SCAPE LIVING : CARRIAGEWORKS

DA DESIGN RESPONSE

D/2016/1388 : 35-47 WILSON LANE, DARLINGTON

This report has been prepared in response to the feedback received 18 May 2017 from City of Sydney relating to Development Application D/2016/1388.

View 2e : entry from Wilson Street

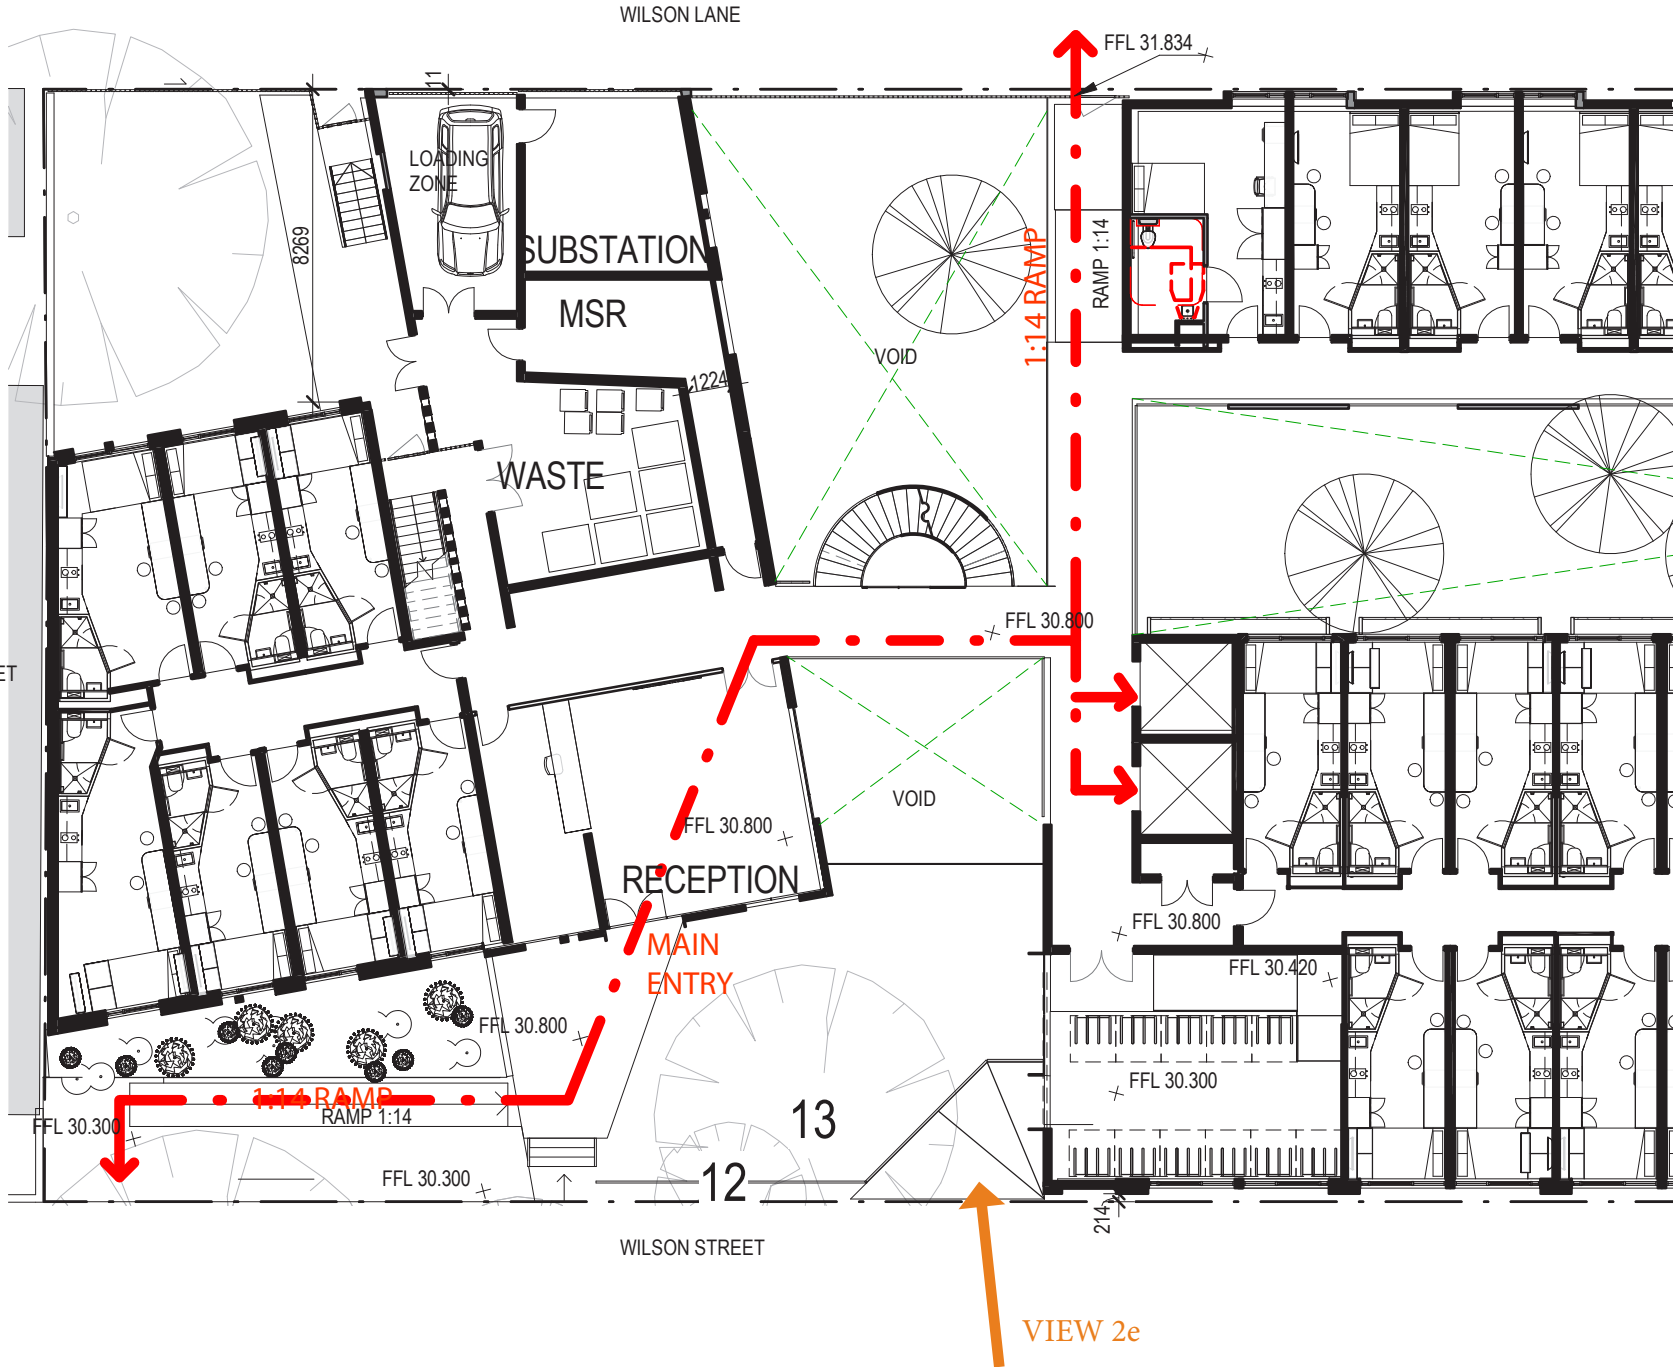
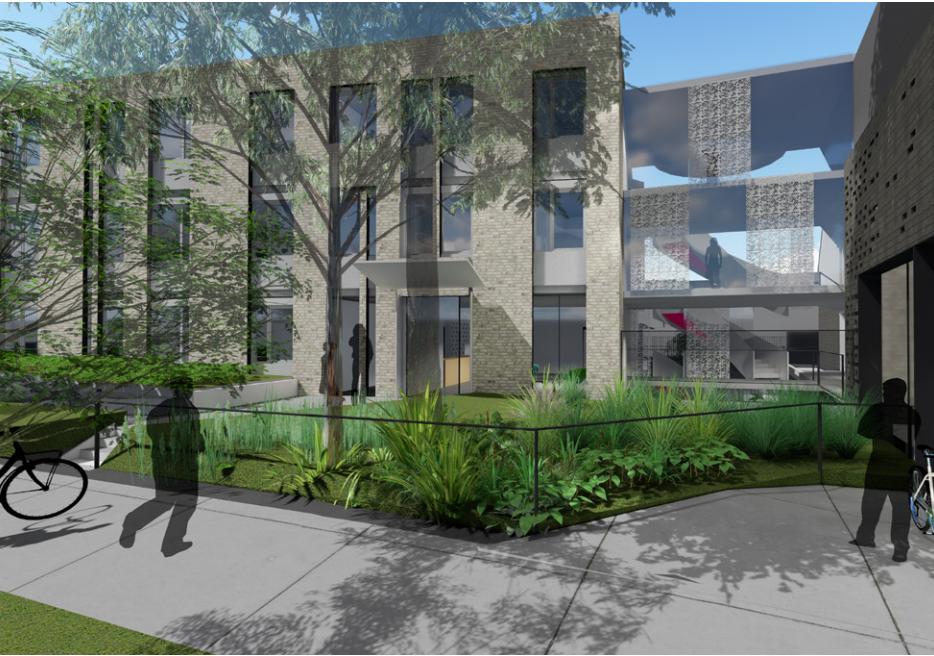
2e ACCESS TO GROUND FLOOR

There are two access points to the proposal for residents to use. The main entry is off Wilson Street with a secondary access point on Wilson Lane recognising desire lines to the University of Sydney.

These two access points provide an accessible route from the Street and Lane into the Ground Floor and from there lift access is provided to the other levels.

The accessible route is not separate to ,or isolated from ,the main thoroughfares but is equitable in that it utilises the main circulation paths and entry points.

South Facade Detail - Eastern end highlighting 1800mm high fence

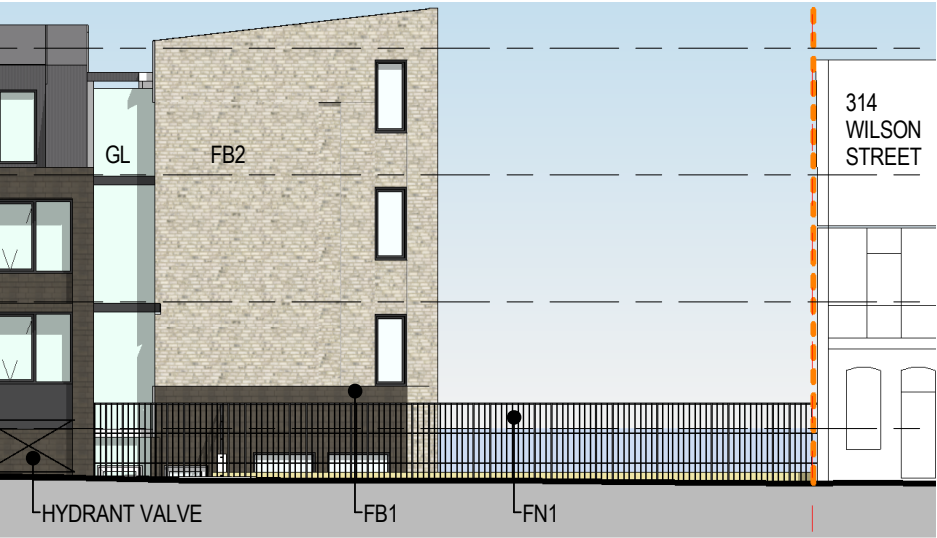
f	Detail of screens and fencing	The fencing on the street and adjoining neighbours is limited to 1800mm height.	Refer to Section 2f for details
	g	Confirm location of chillers and visibility from street	The majority of chillers are located centrally within the site to limit any negative acoustic or visual impacts.	Refer to Section 2g for details
	h	Provide elevations without trees	elevations are provided with and without trees	Refer to the architectural drawings
TREES ON WILSON STREET		The Council’s arborist is not convinced that these would survive the construction phase with the current setbacks. A larger setback is required and should be supported by arborist root mapping	The setback to the tree 12 and 13, on Wilson Street, has been increased. Moore Trees has reviewed and supports the setbacks.	Refer to Section 3 for details
TREE NUMBER 1		Council are not convinced that this tree will survive due to the low canopy and vehicle clearances. Council would like to see a greater setback.	The building has been substantially reconfigured to accommodate a larger setback to this tree at all levels. The setback has been increased by 2300mm. Furthermore the service / loading bay has been incorporated into the building envelope therefore removing the concern of vehicle clearance with the low canopy.	Refer to Section4 for details

The City of Sydney Heritage DCP permits side and rear fences to 1800mm high with new front fences, of an open or partially transparent nature to 1500mm.

The proposal has 1800mm high fencing to the rear boundary, along Wilson Lane, of a semi-open nature. This fenicing will be constructed of vertical metal uprights as a modern interpretation to the traditional palisade style fencing along the street, refer images adjacent.

There is a segment of fencing required at the eastern end of the elevation fronting Wilson Street, refer extract of South Elevation below. It is proposed that this fence be the same as the rear fencing to a height of 1800mm. This fencing restricts access into the communal courtyards and is required for the safety of the residents hence the height of 1800mm.

Side fences will be 1800mm high.

View 2g : entry from Wilson Street

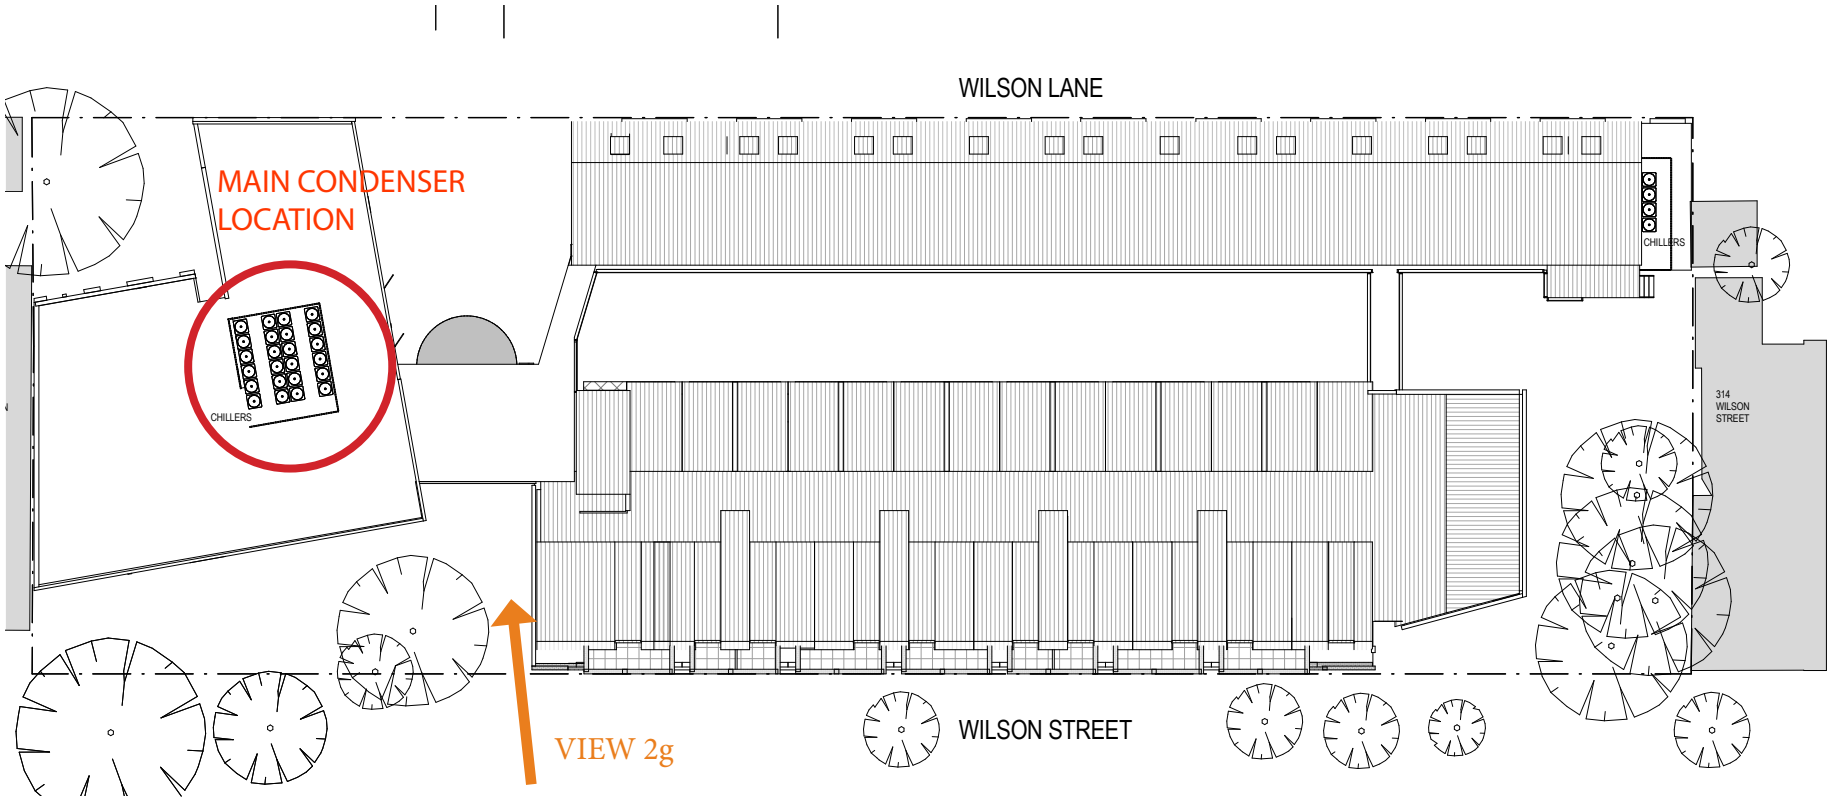
2g LOCATION OF CONDENSERS

The bulk of the condenser units are located on Level 3 setback 19m from the neighbouring property to the west. The condensers will be screened but given their location they will have minimal visual impact, refer to view from Wilson Street below.

A small number of condenser units are located near the eastern boundary on Wilson Lane. The condenser units are located away from habitable spaces within the neighbouring property and screened to reduce visual and acoustic impact.
